Delegated officer report for planning application

Application no. 142383/FH/2025

Proposal: Erection of a freestanding carport canopy together with installation of sliding access gates in association with the widening of access from existing road

Address: 1 Bloomesbury Avenue, Manchester, M20 2BN

Submitted proposed site plan and elevations

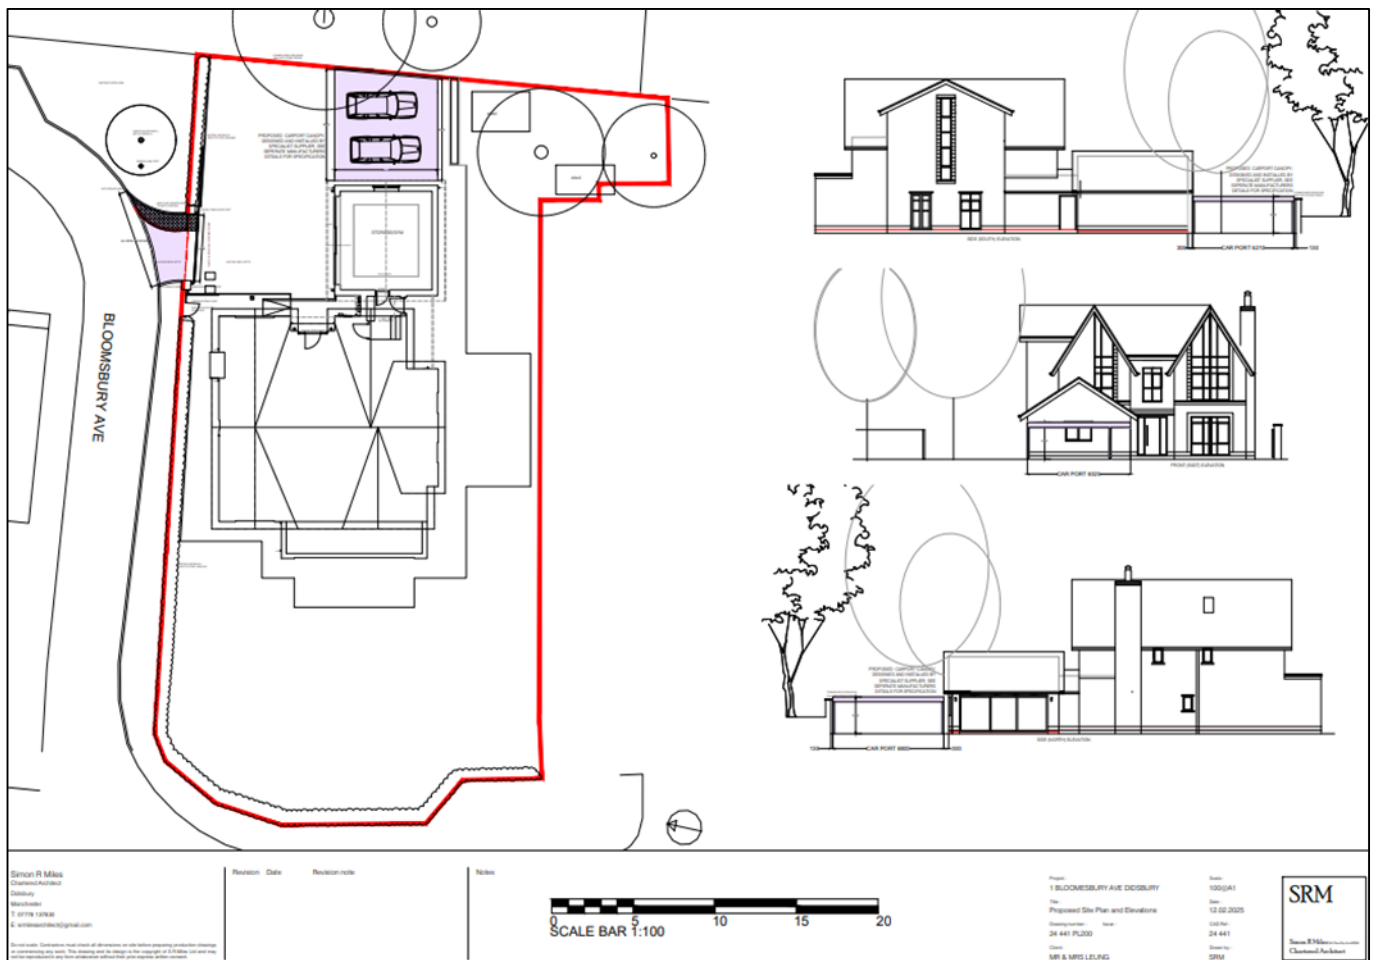
Siting, scale, and massing – the freestanding carport canopy would be sited to the east of the host dwellinghouse on the existing driveway surfacing. It would measure to 6.8m in width at the front (north), 6.21m in width to the rear (south), with a length/depth of 6.325m and a flat roof height of 2.25m. It would be sited along the boundary shared with properties on Didsbury Park

The overall siting, scale, and massing of the proposal is considered to be acceptable as the carport canopy is understood as being subservient to the host dwellinghouse in terms of its dimensions, would avoid resulting in an 'excessively large or bulky' addition to the property, and would not cause undue harm to the residential amenity of neighbouring occupiers in terms of introducing an overbearing feature into the area. Sufficient private outdoor amenity space would also be retained to the west of the existing dwellinghouse.

Appearance and visual amenity – the submitted application form and design & access statement indicate that the carport canopy would consist of a dark grey painted steel frame with an obscurely glazed glass roof. It would be located more than 7m away from Walkershall Way, would be set below the height of the existing mature hedging / boundary treatment to the north and slightly above the high-level redbrick wall to its east.

It is considered that the proposal is relatively standard in terms of its design and scale for developments of this type and would be in-keeping with the existing precedent of residential extensions in this locale. Sited to the east of the property, the proposal would not be highly visible within the street scene or public realm, on account of its considerable setback from the roadway in addition to the high-level boundary treatment and mature foliage present to its northern boundary with Walkershall Way and the retained high-level redbrick wall to its eastern boundary with the residential properties of Didsbury Park, which should largely screen it from public view. Further to this, as a modern metal structure, it would complement the style of the existing dwellinghouse, ensuring that it does not form a prominent visual feature. Hence, the overall character of the property and its surrounding area should not be significantly harmed by these works.

Impact upon the Didsbury St James Conservation Area – given that the proposal would be sited to the east of the property, utilising contemporary and visually sympathetic materials to the host dwellinghouse (which would provide a blended appearance with the existing property), with a considerable setback from the public highway and associated footpath and would predominantly be screened from view by the existing high-level boundary treatment and mature foliage present along the plot's perimeter to the north and east, it is considered that the degree of harm caused to the visual amenity of the area and the character of the Didsbury St James Conservation Area would be limited.

Residential amenity – given that the carport canopy would be a lightweight single storey construction with a maximum flat roof height of 2.25m, with adequate gaps maintained to the plot's shared boundaries, screened from view by the existing high-level boundary treatments to the north and east (bordering Walkershall Way and the residential properties of Didsbury Park) and used for non-habitable storage space for vehicles, it is considered that it should not cause issues associated with overshadowing, loss of light, loss of privacy, or loss of outlook, nor should it introduce an overbearing presence into the area.

Parking and impact upon adjacent roads – the carport canopy would provide secure, sheltered parking for 2no. vehicles. Space for the parking of additional vehicles would also be retained on the driveway to the east of the existing dwellinghouse. These arrangements are considered acceptable and would ensure on-street build-up of traffic and parked vehicles is avoided, pursuant to policies SP1 and DM1 of the Manchester Core Strategy.

Boundary treatment – the proposal also includes the cutting back of the mature hedging to the plot's northern boundary, the repositioning of the existing gateposts and the installation of new sliding gates.

In terms of their visual impact, these alterations are considered acceptable given that the sliding gates would match the appearance of the existing gates present on site, would allow for the retention of the existing gateposts with only a small portion of the hedging removed. This alteration would therefore be barely discernible and would have a neutral impact upon the heritage significance of the site and surrounding area.

The sliding gates would not project onto the adjacent footpath or roadway and, as such, no concerns have been raised in relation to pedestrian or vehicle safety. As the sliding gates consist of black-painted steel railings-style gates similar in appearance to the existing, the visibility splay in and around the site would be largely unaffected by these alterations.

To further safeguard the visual amenity of the area, a condition requiring the submission of samples and/or specifications of the carport canopy materials has been attached to the consent.

To further safeguard the character of the Conservation Area, a condition requiring the submission of samples and/or specifications of the carport canopy materials has been attached to the consent.

4) Above-ground construction works shall not commence until specifications and/or samples of all materials to be used in the external elevations of the carport canopy have been submitted to and approved in writing by the City Council as Local Planning Authority.
